**Appeal No. A-4-OXN-07-096**  
Southern California Edison Co.

## **2nd CORRESPONDENCE PACKET**

**RE: Appeal of the City of Oxnard's Denial of the Southern California Edison (SCE) Peaker Plant Coastal Development Permit (CDP), Located at 251 North Harbor Boulevard: Appeal No. A-4-oxn-07-096**

PHOTO OF THE SCE PEAKER PLANT PROJECT SITE  
FROM FIFTH STREET LOOKING NORTH  
MANDALAY BEACH PARK (UNIMPROVED) IN FOREGROUND

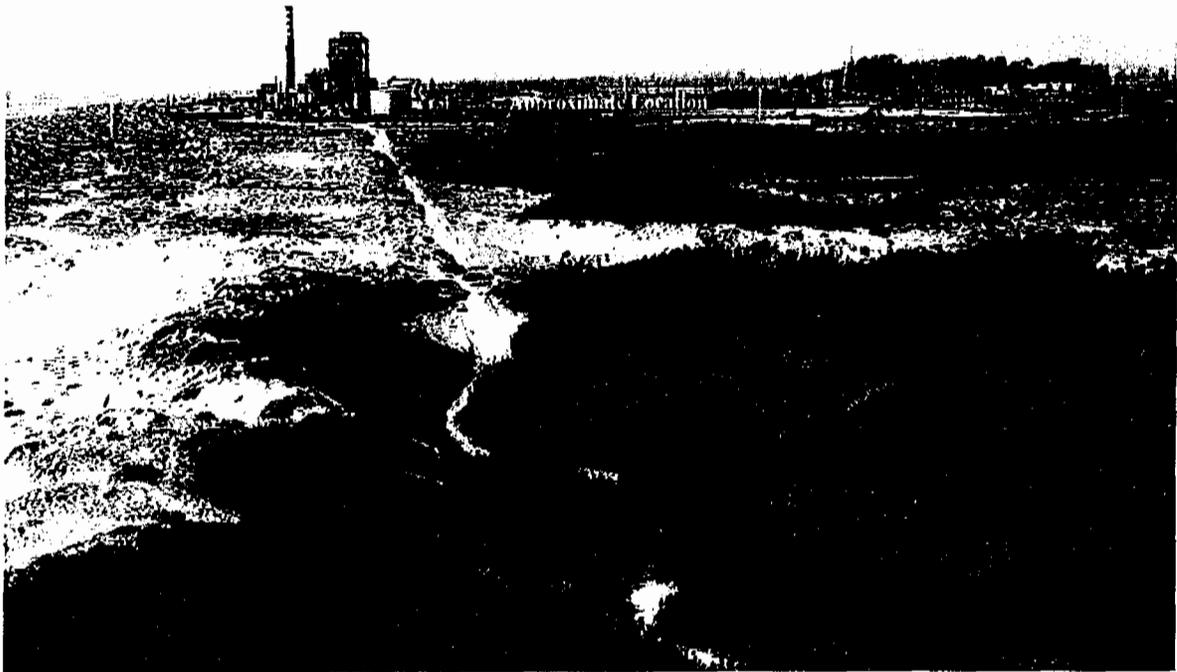
3. Page 4, paragraph 3 states, “The peaker plant will therefore be sited in an area surrounded by other industrial development.” This is factually incorrect. Immediately adjacent to the project parcel to the south is Mandalay Beach Park, unimproved land zoned Resource Protection which is planned for coastal access and recreation by the Oxnard Local Coastal Program, Policy 67. To the southeast and adjacent across Harbor Boulevard is the 292-unit Northshore at Mandalay Bay residential development currently under construction. As the SCE project driveway extends to the southeast corner of the parcel, both the project and the SCE parcel adjoin non-industrial uses. To the immediate west of the SCE parcel is a 200-foot wide energy facility, then approximately 500 feet of dunes and beach. To the east across Harbor Boulevard is land zoned for energy use, but contains only transmission lines and is largely a dunes habitat. It is factually incorrect to state that the SCE project site is “...surrounded by other industrial development” and findings that rely directly or indirectly on that assertion cannot be made by the Coastal Commission. Attached Figure C is a recent aerial photo of the project site which clearly shows it is abutting non-industrial uses on three sides.

# California Flood Risk: Sea Level Rise Oxnard

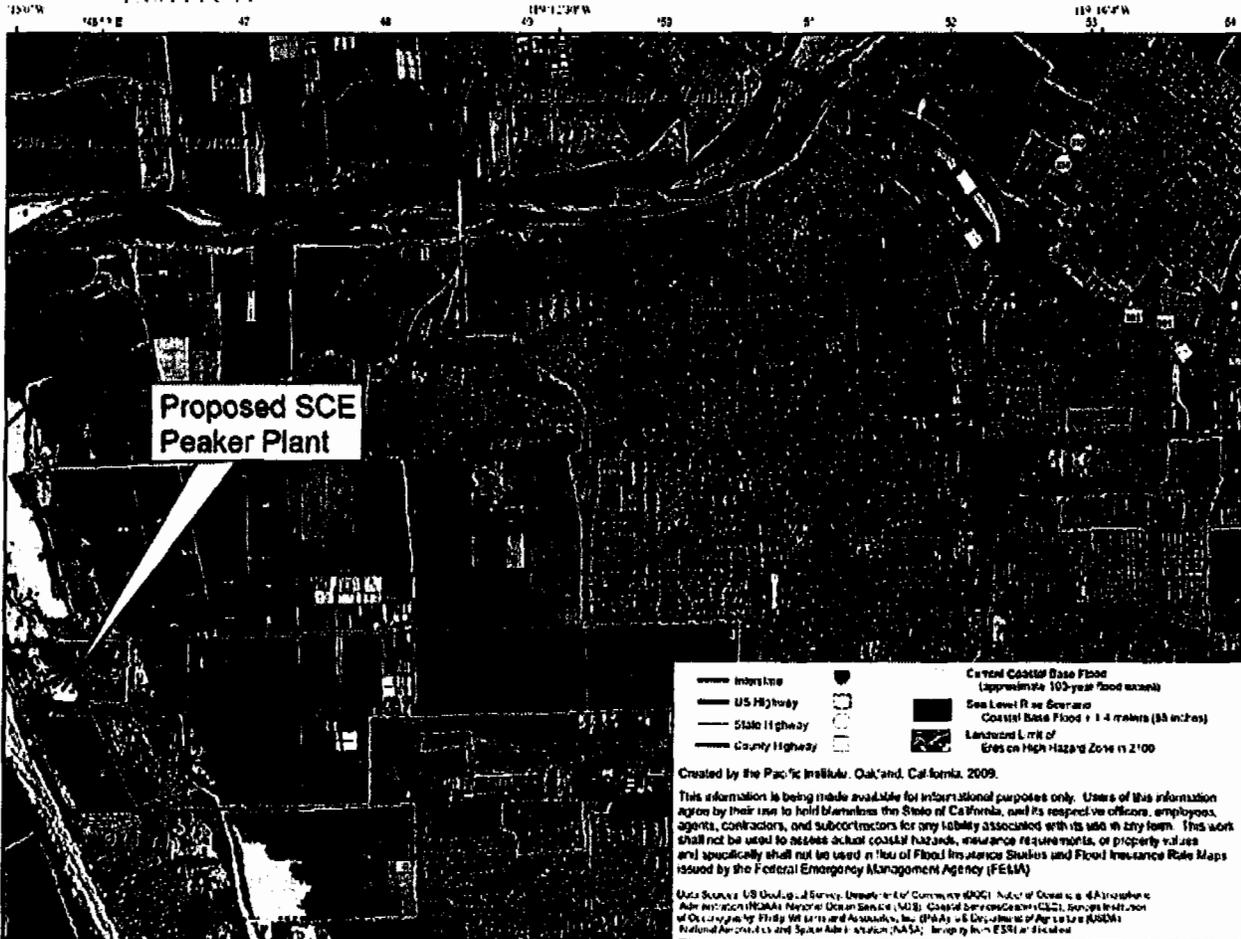
The March 2009 report by the California Climate Change Center includes a sea level rise map that places the proposed peaker plant within the 1.4 meter coastal base flood zone (Attachment 1). The report notes that many coastal public and private structures and uses need to be evaluated in the coming years, including 30 coastal power plants. The report states, "Continued development in vulnerable areas will put additional areas at risk and raise protection costs."<sup>12</sup> It does not make sense to locate a \$60 million major critical public facility in an area that is identified as being inundated by sea level rise.

California  
Transmission Lines - Substations  
and Selected Power Plants  
Lower Map

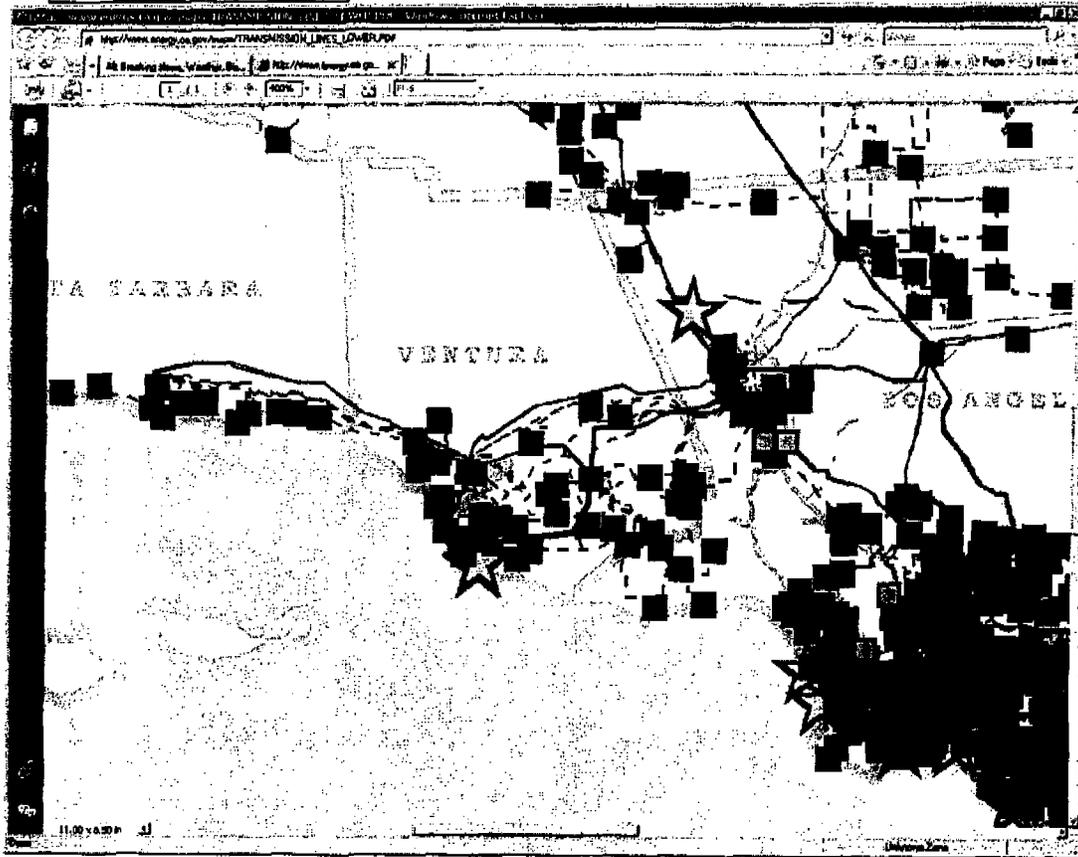
The attached Figure A, taken from the Energy Commission website, shows numerous substations in Ventura County, southern Kern County, and the San Fernando Valley which is the service area, presumably, in need of the extra generation capacity. The PUC Assigned Ruling that initiated SCE's building of five peaker plants states "...the demand forecasts used to plan for resource needs in California may not have fully incorporated the impacts of recent population growth in the warmer inland areas of California." SCE's criteria

The attached Figure A, taken from the Energy Commission website, shows numerous substations in Ventura County, southern Kern County, and the San Fernando Valley which is the service area, presumably, in need of the extra generation capacity. The PUC Assigned Ruling that initiated SCE’s building of five peaker plants states “... the demand forecasts used to plan for resource needs in California may not have fully incorporated the impacts of recent population growth in the warmer inland areas of California.” SCE’s criteria for site selection, Attachment B, are so limited so as to preclude any other site except Oxnard. SCE should not be able to use “too much grading” or “road degraded” as reasons to develop a coastal site over an inland site. SCE should not be allowed to use the “fast-track” reasoning to select Oxnard over another inland location as they have already spent 18 months pursuing this project that could have been spent building the peaker at another location. It is the City’s position that each SCE substation location should be thoroughly evaluated before the Coastal Commission, in conjunction with the Energy Commission, may conclude that the only viable site is in the coastal zone.

**Response CCL-1-1:** This comment is based on the mistaken premise that the proposed peaker plant (the “Project”) falls within the authority of the Energy Commission to certify proposed powerplant sites, and that the Energy Commission is therefore required to determine that the Project site has “greater relative merit” than available alternative sites pursuant to Public Resources Code sections 30264 and 25516.1. Because the proposed Project would have only 45 megawatts of electric generating capacity, it does not fall within the siting jurisdiction of the Energy Commission. As such, Public Resources Code sections 30264 and 25516.1 do not apply; therefore, no determination from the Energy Commission regarding alternative sites is required.
